**DEPARTMENT OF GENERAL SERVICES, PURCHASING DIVISION**

**ADDENDUM # 6**

**CAPITAL PROJECT 3414:  
CONSTRUCTION OF NEW HIGHWAY FACILITY**

**Questions and responses to RFI's #1, 2, 3, 5, 6, 8, 9, 10, 13 and 14. All other RFI's are being looked at and will be responded to shortly.**

PROJECT RCNG  
 PROJECT NO. 130439 SCALE N.T.S.  
 CALCULATED BY \_\_\_\_\_ DATE \_\_\_\_\_  
 CHECKED BY \_\_\_\_\_ DATE \_\_\_\_\_  
 SUBJECT CRUSHED STONE DETAIL SHEET NO. 1 OF 1 REVISIONS \_\_\_\_\_

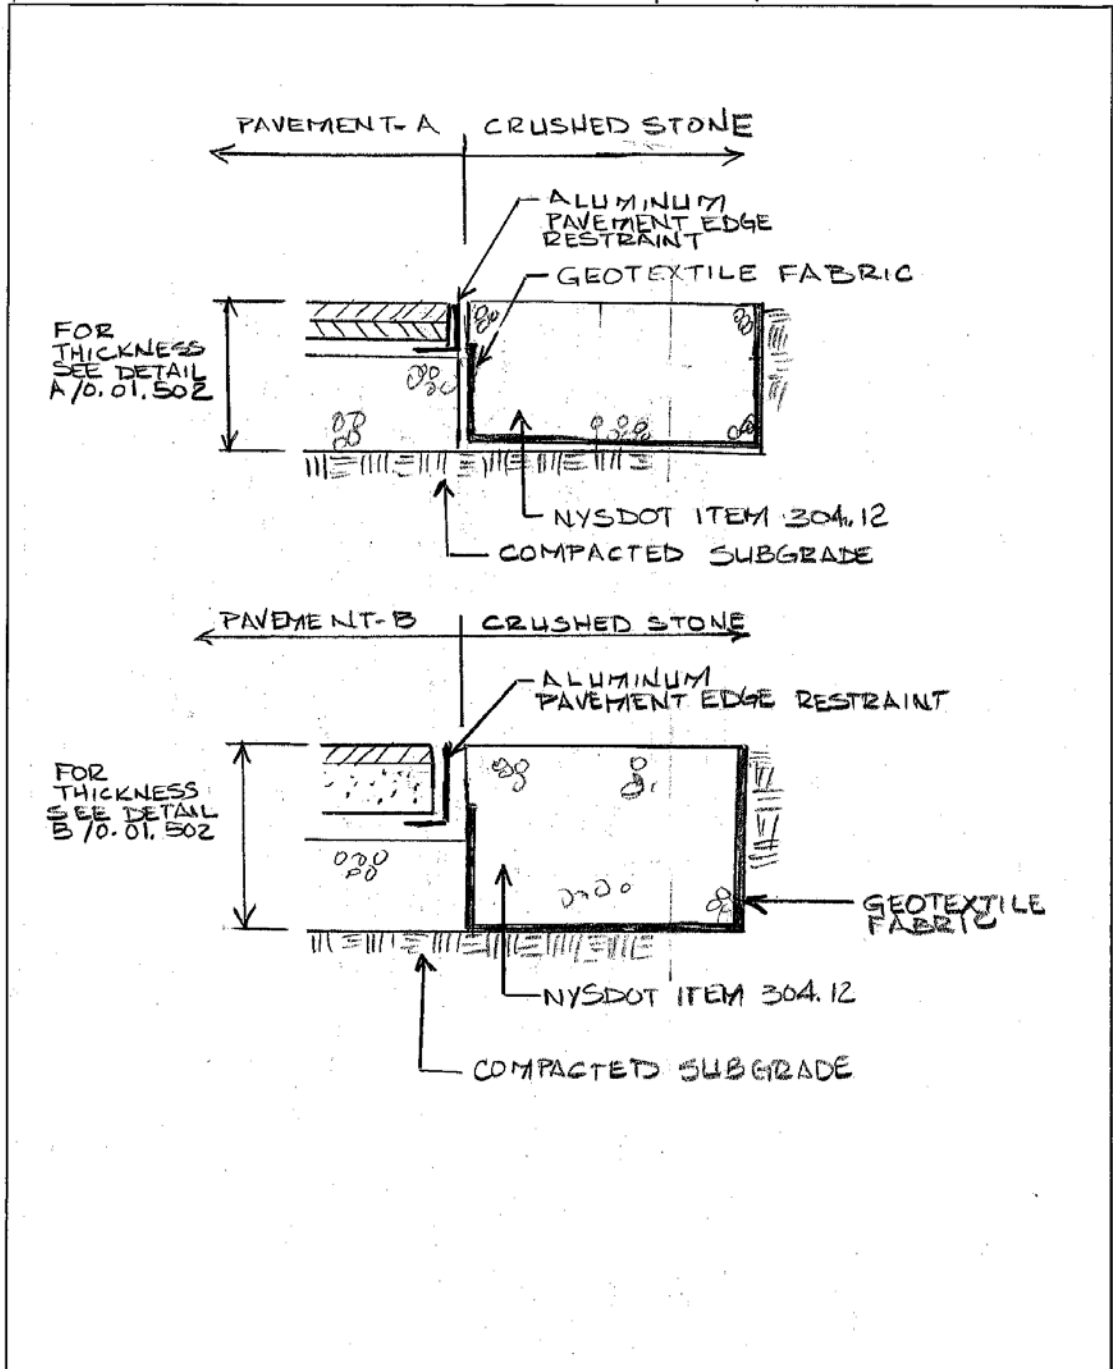
11. Drawing # 0.01.101 - Site Plan Sheet 1 of 4: Provide make up of "Crushed Stone Surface" as other crushed stone areas on the plan are identified with a material, thickness etc. **(RFI NB01)**

**Response:** Unless otherwise noted crushed stone shall be NYSDOT Item 304.12. **See attached detail sketch.** Formal detail will be included in Addendum drawings
